# Access Compliance Report

## Public Rights-of-Way

### (Curb Ramps)

Intersection ID: 10016945	Main Street: WINTERFIELD_PL	Cross Street: CAMPBELL_DR	Location: E
ADA ID: CE0F0D97F455	Ramp Type: Perp	Initial Pass/Fail: Fail	Overall Compliance: No
Severity Score: 12.5			
Codes/Mitigation Info/Possible Solution		Field Measurements/Component Compliance

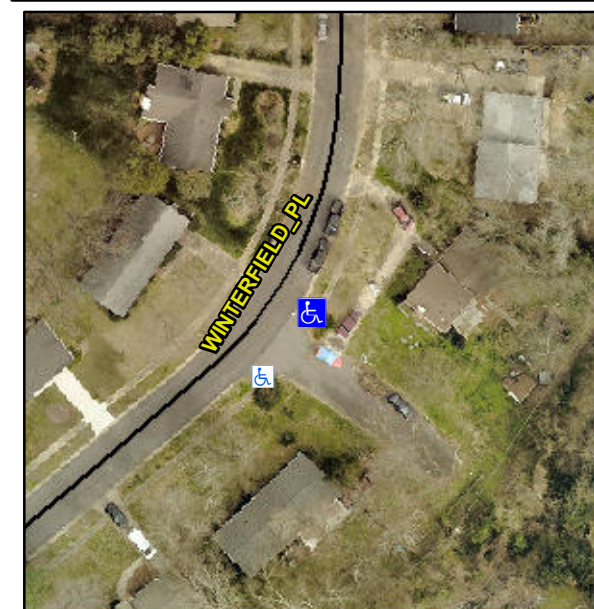
**Not Found, R304.5.3**

Compliance	Description	Data	Compliance	Description	Data
N/A	Ramp Length (in)	32.0	Yes	Ramp Slope (%)	5.2
Yes	Ramp Width (in)	48.0	No	Ramp XSlope (%)	6.6
N/A	Flare Type LT	N/A	N/A	Flare Type RT	N/A
N/A	Flare Slope LT (%)	N/A	N/A	Flare Slope RT (%)	N/A
N/A	Flare Traversable LT?	N/A	N/A	Flare Traversable RT?	N/A
N/A	Landing Length (in)	N/A	N/A	DWS Provided?	N/A
N/A	Landing Width (in)	N/A	N/A	DWS Contrast?	N/A
N/A	Landing Slope (%)	N/A	N/A	DWS Length (in)	N/A
N/A	Landing X Slope (%)	N/A	N/A	DWS Full Width?	N/A
N/A	Landing Curb? (Y/N)	N/A	N/A	DWS Offset (in)	N/A
N/A	Shared Landing?	N/A			
N/A	Gutter Ponding?	N/A	N/A	Gutter Slope (%)	N/A
N/A	Gutter Lip Ht (in)	N/A	N/A	Gutter X Slope (%)	N/A
N/A	Painted X Walk1?	No	N/A	Painted X Walk2?	N/A
	X Walk 1 Direction	To SW		X Walk 2 Direction	N/A
N/A	X Walk 1 Width (in)	N/A	N/A	X Walk 2 Width (in)	N/A
	X Walk 1 Slope (%)	0.6		X Walk 2 Slope (%)	N/A
	X Walk 1 X Slope (%)	7.8		X Walk 2 X Slope (%)	N/A

**Remove & Replace Entire Ramp.**
